City of  
Peterborough

## Committee of Adjustment

Hearing Date: March 30, 2021

Staff Recommendations Regarding Files: A25/20, A08/21, A09/21, A10/21, A12/21, A13/21, A14/21, A15/21, A16/21, and A17/21

PROJECT TITLE:  
SITE PLAN  
556 STEWART STREET  
Peterborough, ON

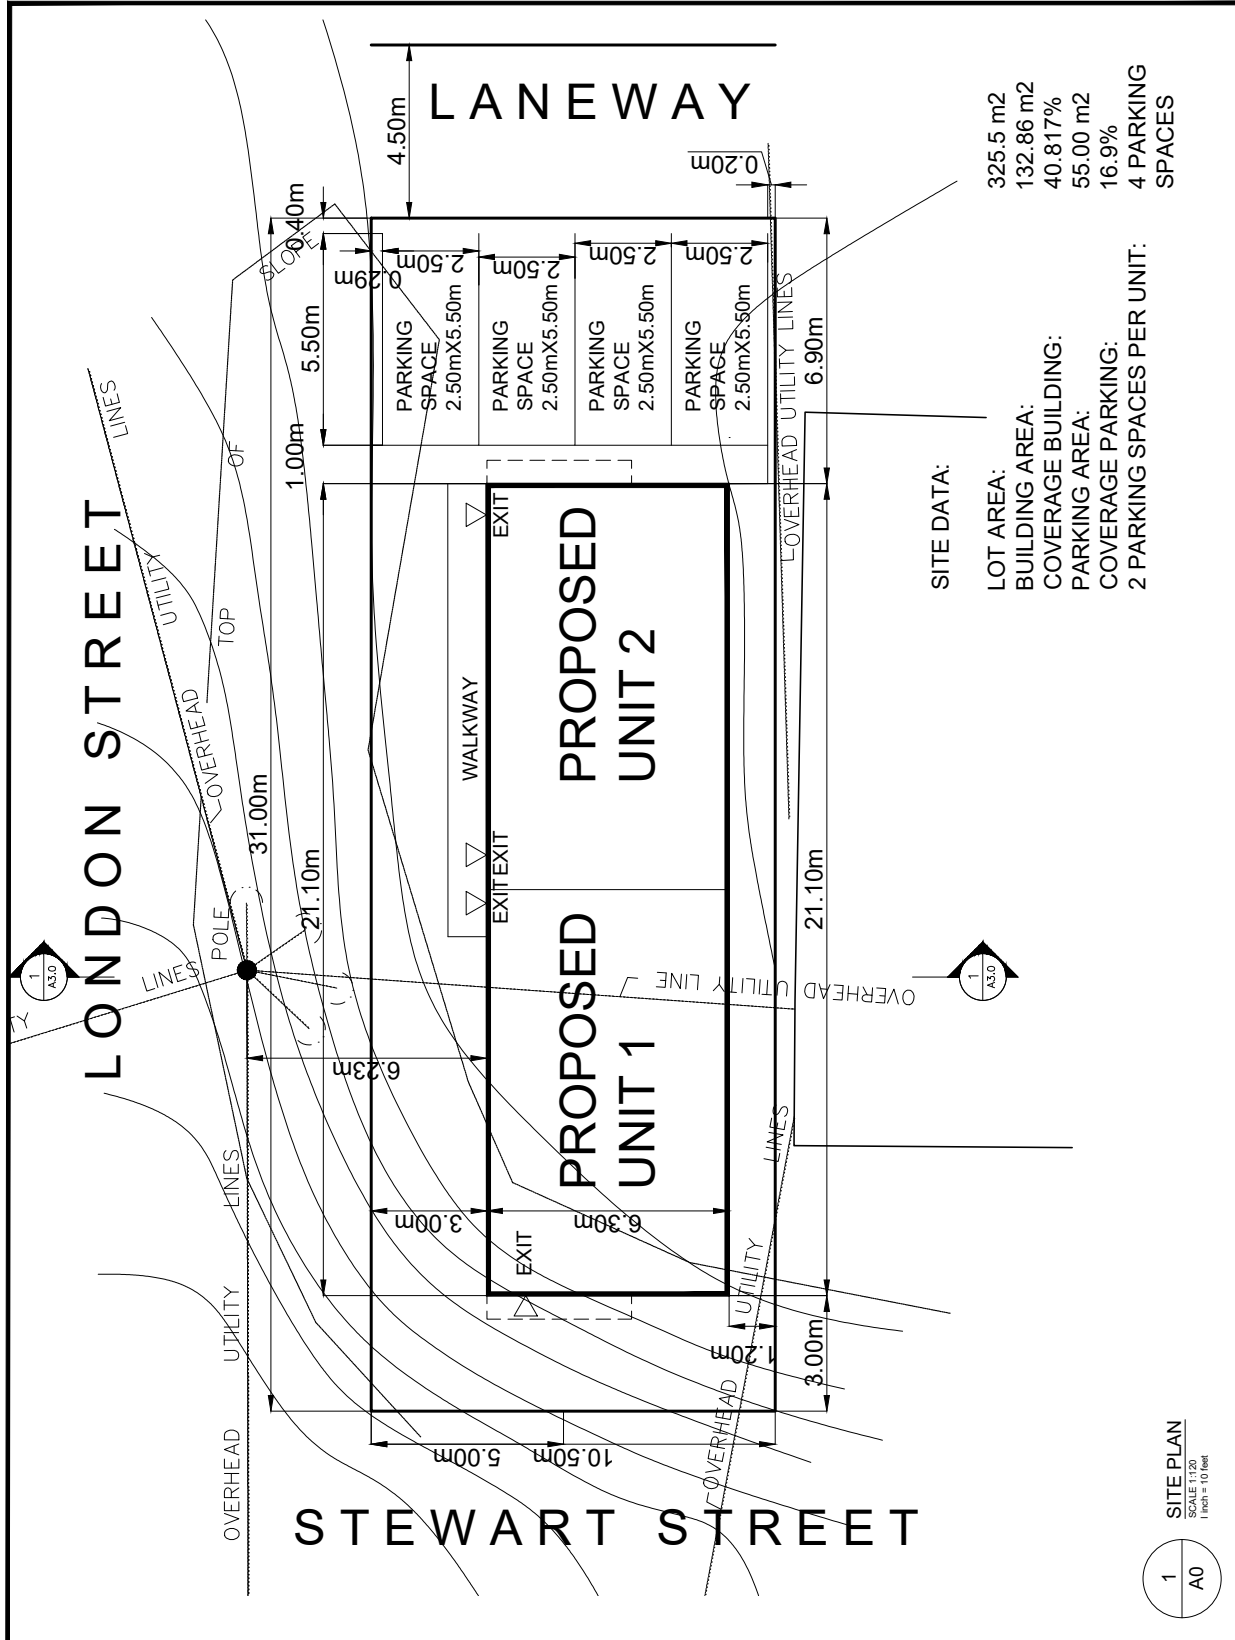
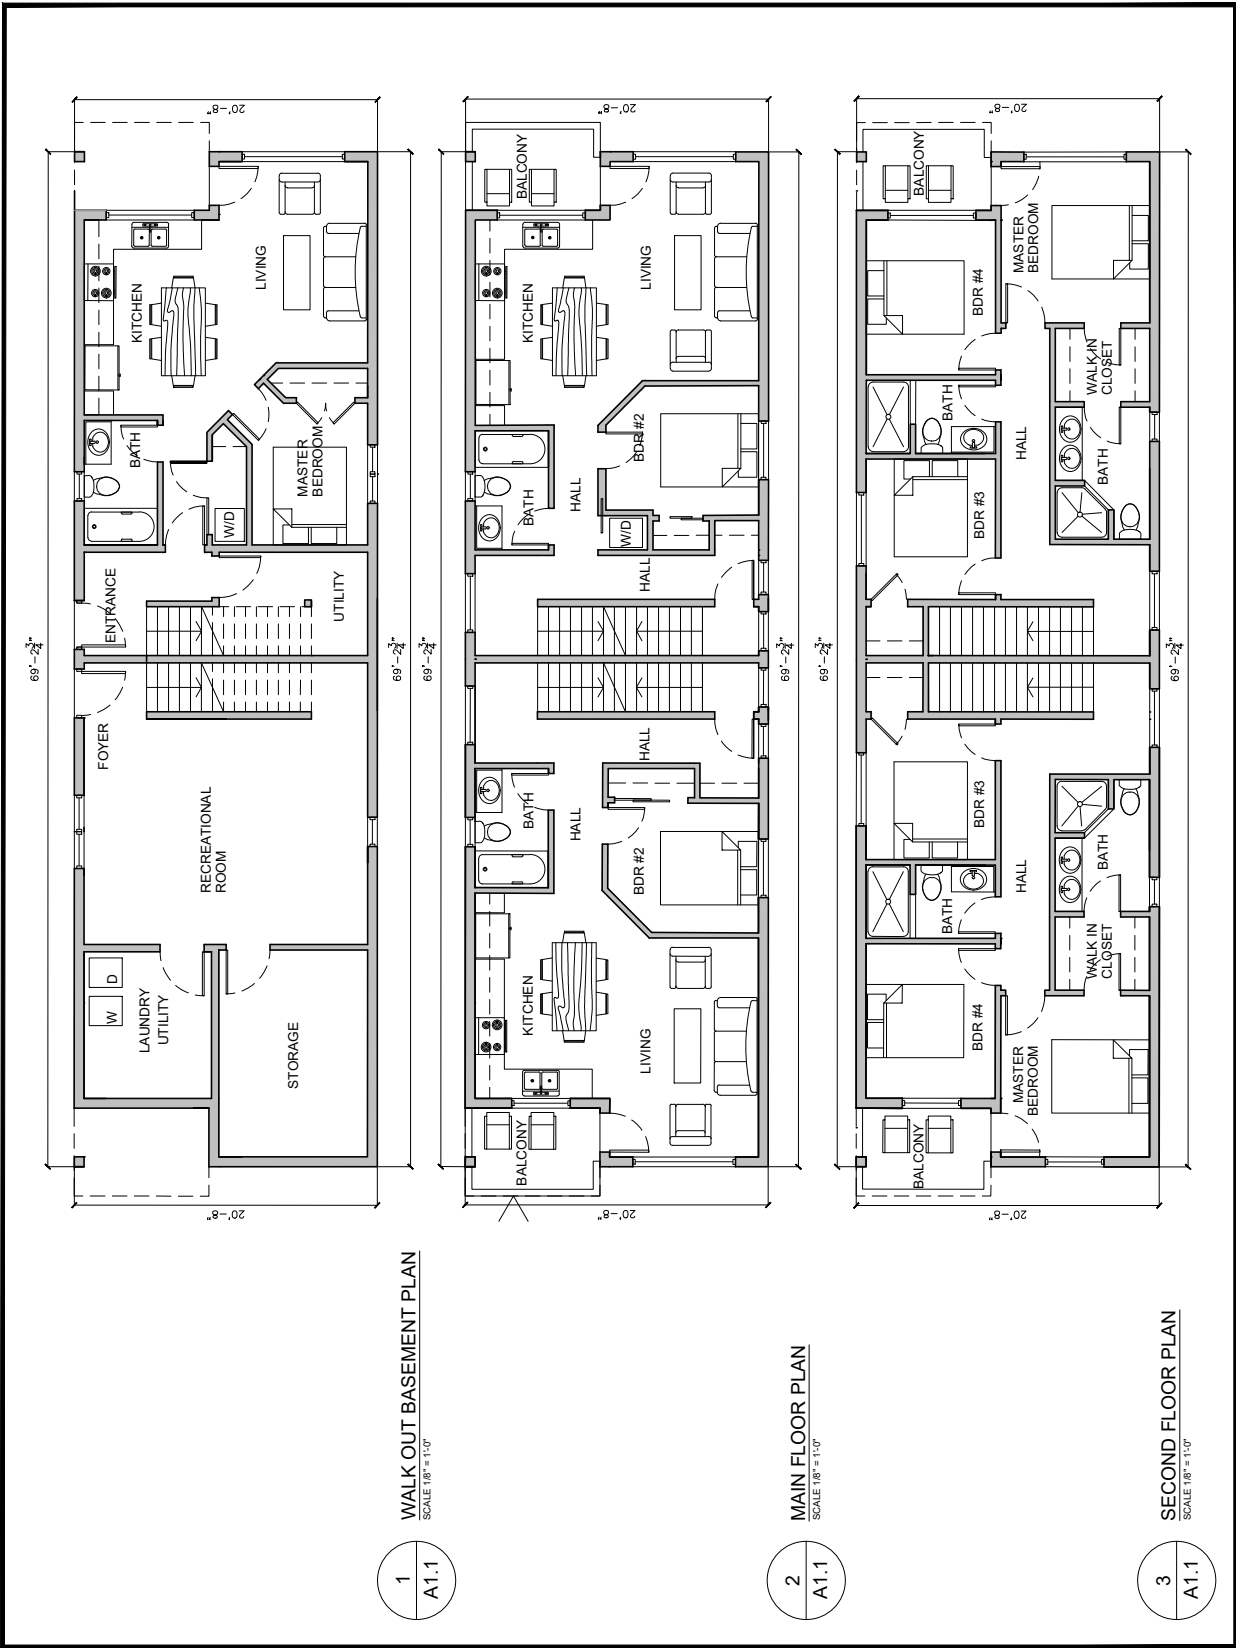
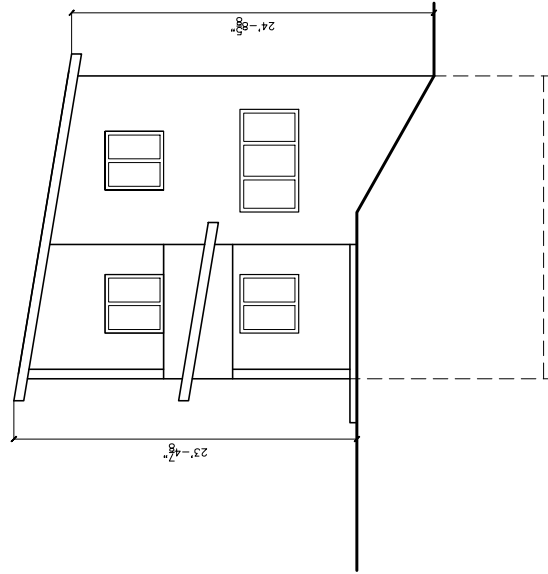
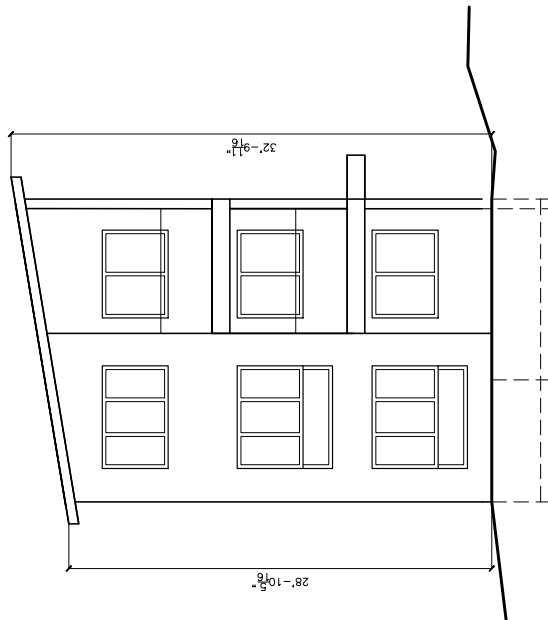
Staff have reviewed Exhibit A considering the guidance provided in Section 4.2.2.1.3 above and are of the opinion that the built form derived from the proposed list of variances would create a departure from the existing streetscape. A smaller scale building, possibly a single dwelling unit with opportunity for a secondary suite would better suit the restrictions of the property. Reductions in the number of parking spaces and the footprint of the building will improve pedestrian access and stormwater management, while navigating the likely need for retaining wall construction and consideration of the adjacent utility pole and anchors.

The proposed building has a parking arrangement that relies heavily on the presence of the 4.3 metre wide laneway and is seeking relief for the required parking aisle as well as the minimum parking stall size on site. The building footprint has been expanded at the expense of providing adequate on-site parking as well as safe pedestrian access to the building. A parking arrangement where parking is accommodated deeper on site may reduce off site parking impacts and pedestrian-vehicle conflict. A revised concept plan for the property that considers a smaller building footprint (E.g. a single-dwelling with secondary suite), along with reductions in parking will provide more room for walkways,

Staff have reviewed the proposed built form that corresponds with the variances requested and note that the proposed building appears to be greater than two storeys in height, exceeding the R.2 zoning regulations for the number of storeys. Staff have previously requested that the applicant provide section details for review by the Building Division to formally determine the number of storeys – sufficient information to determine this has not, to date, been provided. Based on the information available at this time, the proposed building appears to be three storeys in height and therefore does not maintain the general intent and purpose of the Zoning By-law.

The City's Building Division has provided comment on the proposal and has indicated that the proposed dwelling appears to be a three-storey structure. Supplementary information has been requested to demonstrate the number of storeys does not exceed two. For the building permit application, the applicant will need to demonstrate the location of the first storey as per the lot grade definition and first storey definition of the City's Comprehensive Zoning By-law.

Peterborough Distribution (PD) has reviewed the application and has concerns regarding the ability to achieve adequate clearance from the overhead 27.6kV line (high capacity) on London Street to the proposed building. They have also indicated that anchors on the

The City's Engineering Design and Construction Technologist / Inspector has reviewed the application and has indicated that the floor plans show three units not two, and the lot grading plan must include drainage of the shared driveway, as the proposed layout will result in drainage onto this shared driveway, the plan will have to demonstrate that the proposed drainage will not result in negative drainage issue on the shared driveway or abutting properties.

Further, the Planner, Urban design recommends that the Committee deny the request to reduce the minimum required parking space width from 2.7 metres to 2.5 metres. The reduced parking stall width, combined with the reduced drive aisle/laneway width, will make it very difficult to access the proposed parking spaces. The additional 0.2 metres will provide the necessary space for vehicles to enter/exit the parking stall. Given the reduced drive aisle and narrow, 4.5 metre laneway, an increased parking stall width is recommended to allow for adequate vehicle turning radius.

The City's Senior Project Manager – Transportation has indicated concern regarding the location being a popular choice for student accommodation. They have indicated that with the number of bedrooms presented in the plans, spillover parking on the streets and laneway may result.

Staff recommends that the Committee of Adjustment **deny** the minor variance on the basis that it does not meet the general intent and purpose of the Zoning By-law and Official Plan and would not be desirable for the appropriate development of the land.
